Access Compliance Report

Intersection ID: 28787	Main Street: N_ALEXANDER_ST	Cross Street: PARKSIDE_TERRACE_LN	Location: N
ADA ID: A654C5B56D2D	Ramp Type: Perp	Initial Pass/Fail: Fail	Overall Compliance: No
Severity Score: 12.5			
Codes/Mitigation Info/Possible Solution		Field Measurements/Component Compliance

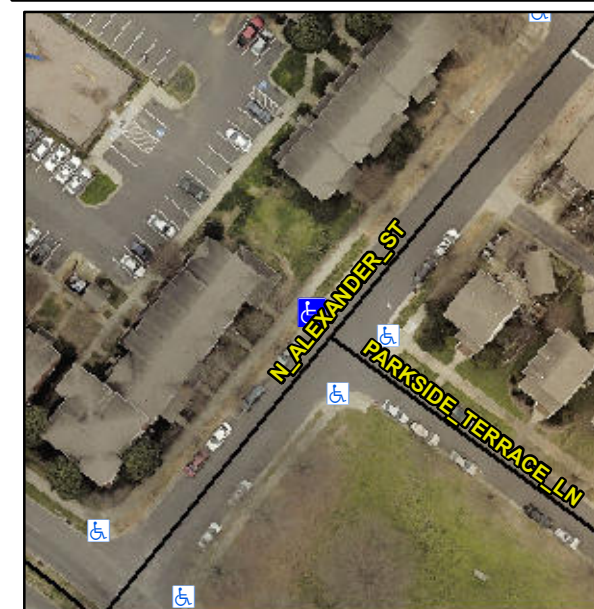
Not Found, R304.2.2

Compliance	Description	Data	Compliance	Description	Data
N/A	Ramp Length (in)	72.0	No	Ramp Slope (%)	8.7
Yes	Ramp Width (in)	50.0	Yes	Ramp XSlope (%)	1.7
N/A	Flare Type LT	N/A	N/A	Flare Type RT	N/A
N/A	Flare Slope LT (%)	N/A	N/A	Flare Slope RT (%)	N/A
N/A	Flare Traversable LT?	N/A	N/A	Flare Traversable RT?	N/A
N/A	Landing Length (in)	N/A	N/A	DWS Provided?	N/A
N/A	Landing Width (in)	N/A	N/A	DWS Contrast?	N/A
N/A	Landing Slope (%)	N/A	N/A	DWS Length (in)	N/A
N/A	Landing X Slope (%)	N/A	N/A	DWS Full Width?	N/A
N/A	Landing Curb? (Y/N)	N/A	N/A	DWS Offset (in)	N/A
N/A	Shared Landing?	N/A			
N/A	Gutter Ponding?	N/A	N/A	Gutter Slope (%)	N/A
N/A	Gutter Lip Ht (in)	N/A	N/A	Gutter X Slope (%)	N/A
N/A	Painted X Walk1?	No	N/A	Painted X Walk2?	N/A
	X Walk 1 Direction	To SE		X Walk 2 Direction	N/A
N/A	X Walk 1 Width (in)	N/A	N/A	X Walk 2 Width (in)	N/A
	X Walk 1 Slope (%)	2.7		X Walk 2 Slope (%)	N/A
	X Walk 1 X Slope (%)	0.1		X Walk 2 X Slope (%)	N/A

Remove & Replace Entire Ramp.
